UNITED STATES PATENT AND TRADEMARK OFFICE

APPLICATION NO.	FILING DATE	FIRST NAMED INVENTOR	ATTORNEY DOCKET NO.	CONFIRMATION NO.
10/774,167	02/06/2004	Christoph Andreas Roth	008932-0875-999	7311
51832	7590	11/01/2005	EXAMINER	
JONES DAY 222 EAST 41ST STREET NEW YORK, NY 10017-6702			SWIGER III, JAMES L	
			ART UNIT	PAPER NUMBER
			3733

Office Action Summary

DETAILED ACTION

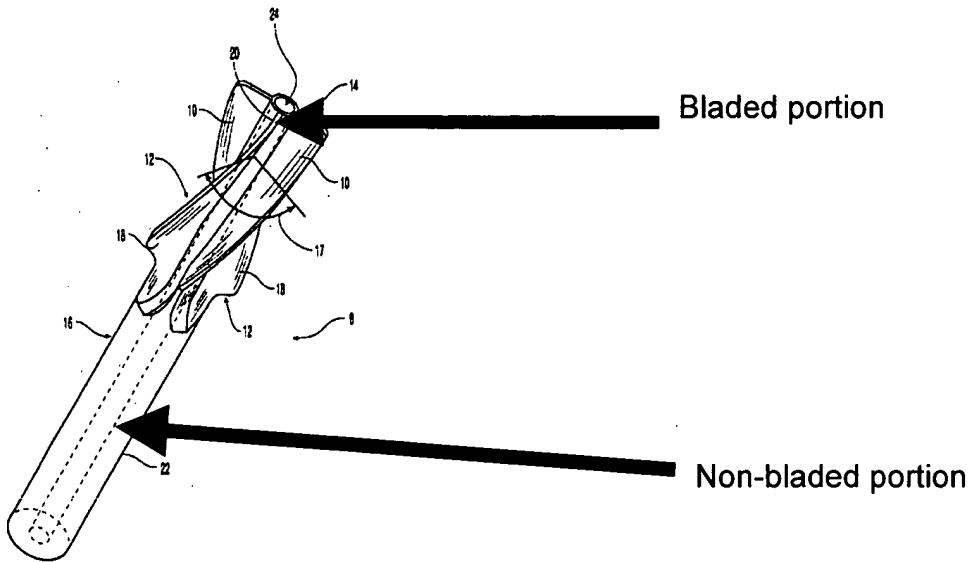
Claims 1,2,4,5,13-16, 23-24 are rejected under 35 U.S.C. 102(b) as being anticipated by Bresina (U.S. Patent No. 5,741,256). Bresina discloses a device having an implant (Fig. 1), a shaft (16) defining a longitudinal axis, a plurality of blades (10 and 12) that are helically twisted (Col. 2, line 26), and has a set of blades that varies longitudinally (Col. 3, lines 15-20). Also disclosed is a variable blade width from proximal to distal ends (Col. 3, lines 23-25), at least one blade with a substantially constant blade width (Col. 3, line 15), the blades twisting about 90 degrees (Col. 3, line 22), an implant configured and dimensioned for implantation into the femoral head (Col. 1, lines 7-8), an implant having a cannulation to receive a guide wire (Col. 3, lines 29-33), and an implant that is capable of attachment with an insertion device. The invention is Bresina further discloses that the maximum diameter of the bladed portion is smaller than the maximum diameter of the non-bladed portion (See Fig. 1 below).
